Access Compliance Report

Public Rights-of-Way

(Curb Ramps)

Intersection ID: 21533	Main Street: LENOX_POINTE_DR	Cross Street: KINGS_PARADE_BV	Location: E
ADA ID: 9A9259C72D16	Ramp Type: Perp	Initial Pass/Fail: Fail	Overall Compliance: No
			Severity Score: 21.25

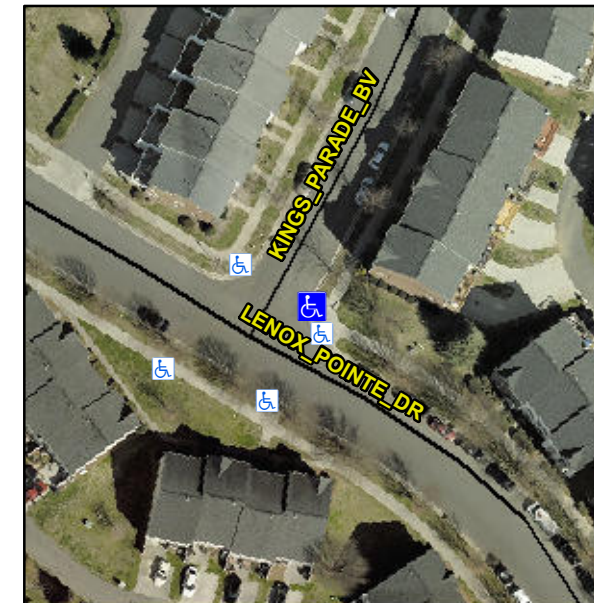
R304.5.1, R304.2.2

Compliance	Description	Data	Compliance	Description	Data
N/A	Ramp Length (in)	76.0	No	Ramp Slope (%)	8.6
No	Ramp Width (in)	45.5	Yes	Ramp XSlope (%)	0.0
N/A	Flare Type LT	N/A	N/A	Flare Type RT	N/A
N/A	Flare Slope LT (%)	N/A	N/A	Flare Slope RT (%)	N/A
N/A	Flare Traversable LT?	N/A	N/A	Flare Traversable RT?	N/A
N/A	Landing Length (in)	N/A	N/A	DWS Provided?	N/A
N/A	Landing Width (in)	N/A	N/A	DWS Contrast?	N/A
N/A	Landing Slope (%)	N/A	N/A	DWS Length (in)	N/A
N/A	Landing X Slope (%)	N/A	N/A	DWS Full Width?	N/A
N/A	Landing Curb? (Y/N)	N/A	N/A	DWS Offset (in)	N/A
N/A	Shared Landing?	N/A			
N/A	Gutter Ponding?	N/A	N/A	Gutter Slope (%)	N/A
N/A	Gutter Lip Ht (in)	N/A	N/A	Gutter X Slope (%)	N/A
N/A	Painted X Walk1?	No	N/A	Painted X Walk2?	N/A
	X Walk 1 Direction	To NW		X Walk 2 Direction	N/A
N/A	X Walk 1 Width (in)	N/A	N/A	X Walk 2 Width (in)	N/A
	X Walk 1 Slope (%)	0.6		X Walk 2 Slope (%)	N/A
	X Walk 1 X Slope (%)	1.2		X Walk 2 X Slope (%)	N/A

Remove & Replace Entire Ramp.
